EDWIN I. HATCH NUCLEAR PLANT UNIT NO. 1

AMENDMENT TO FACILITY OPERATING LICENSE

Amendment No. 35
License No. DPR-57

ATTACHMENT TO LICENSE AMENDMENT NO. 35
TO THE ENVIRONMENTAL TECHNICAL SPECIFICATIONS
FACILITY OPERATING LICENSE NO. DPR-57
DOCKET NO. 50-321

HNP ETS
 FIG. 5-1
 ORGANIZATION RELATIVE TO
 ENVIRONMENTAL MATTERS

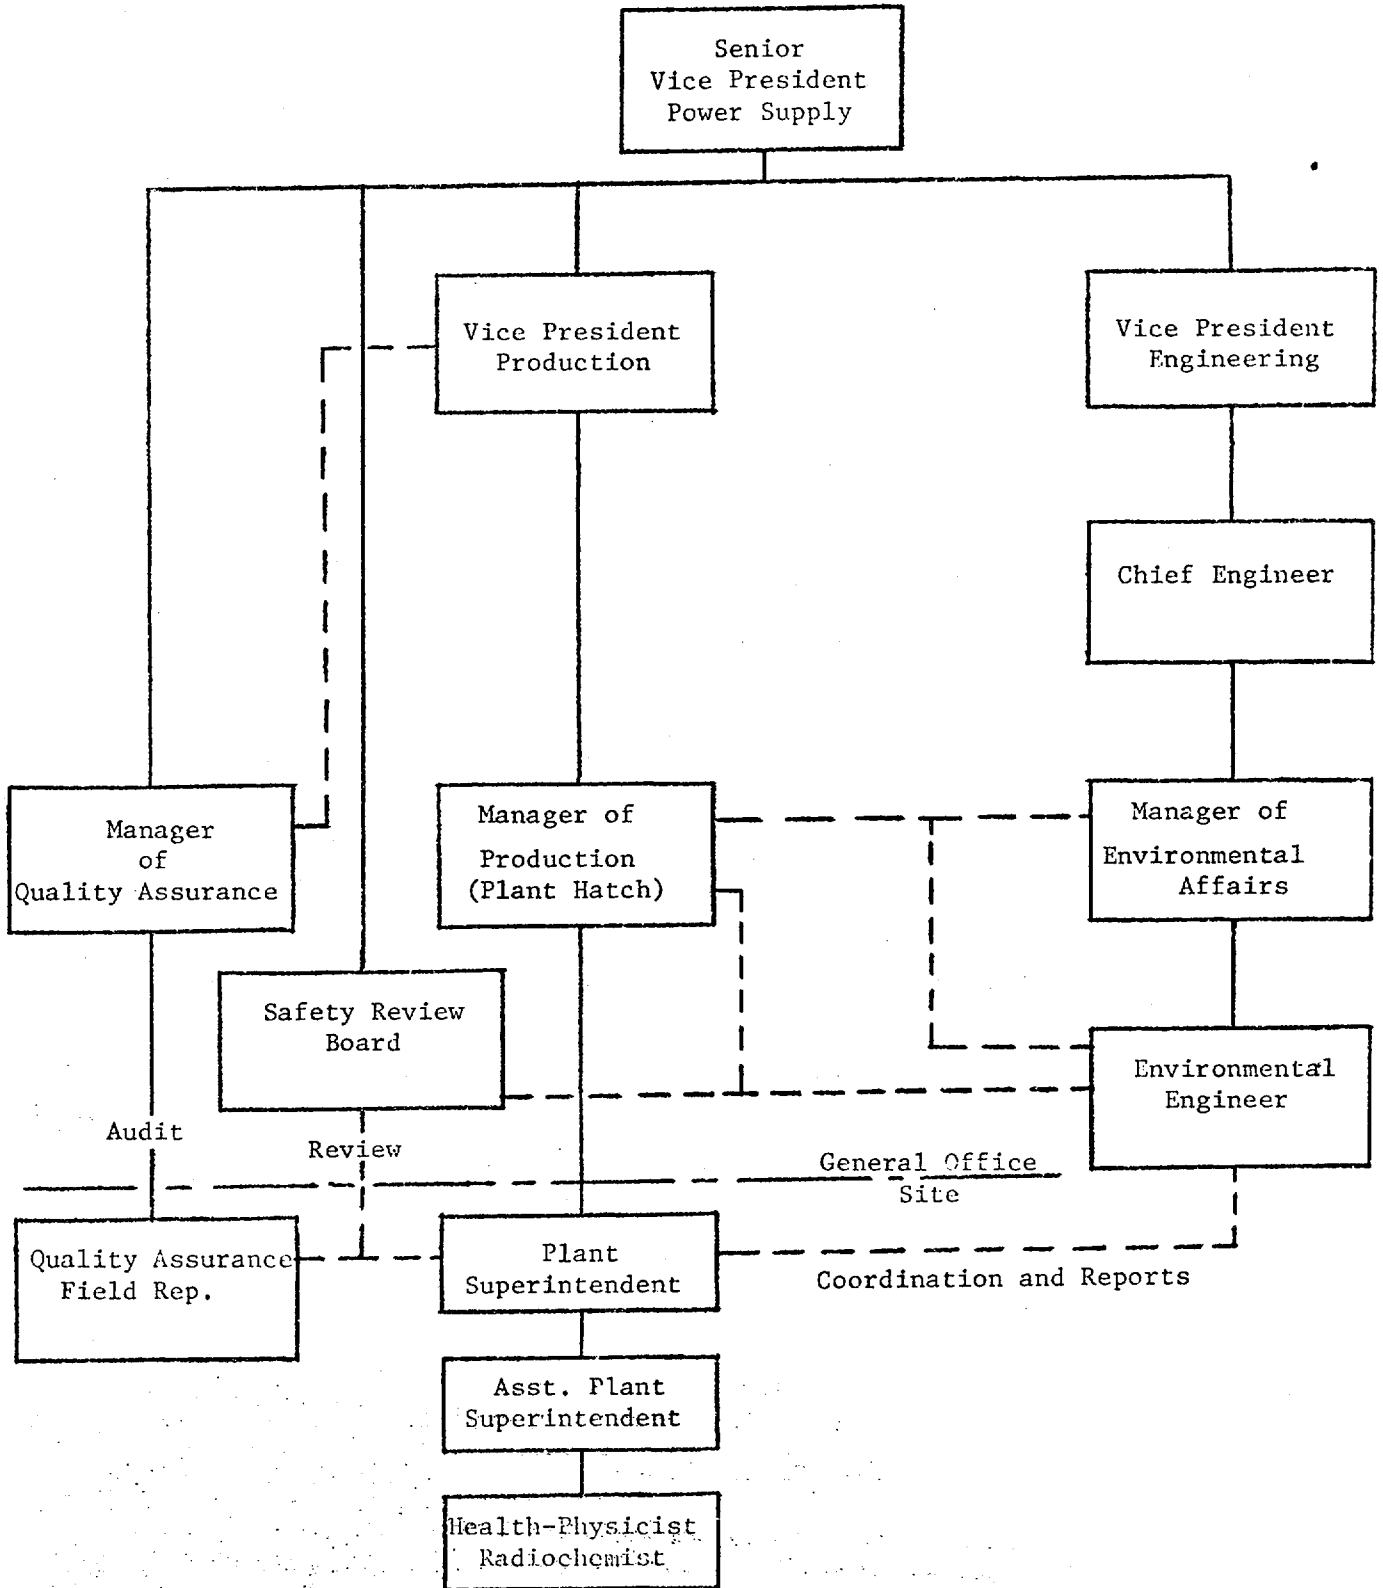
Replace pages 3-3, 4-1 thru 4-3, 5-1 thru 5-4 and Figure 5-1 with the attached revised pages. Add page 5-4a.

An organizational chart showing both plant and corporate levels relative to environmental matters is presented in Figure 5-1. The Production Department has a responsibility for planning and implementing the monitoring of the plant effluents, for observing the limiting conditions for operation, and for those items specified in Technical Specification 5.1.1. The Environmental Affairs Division of the General Engineering Department
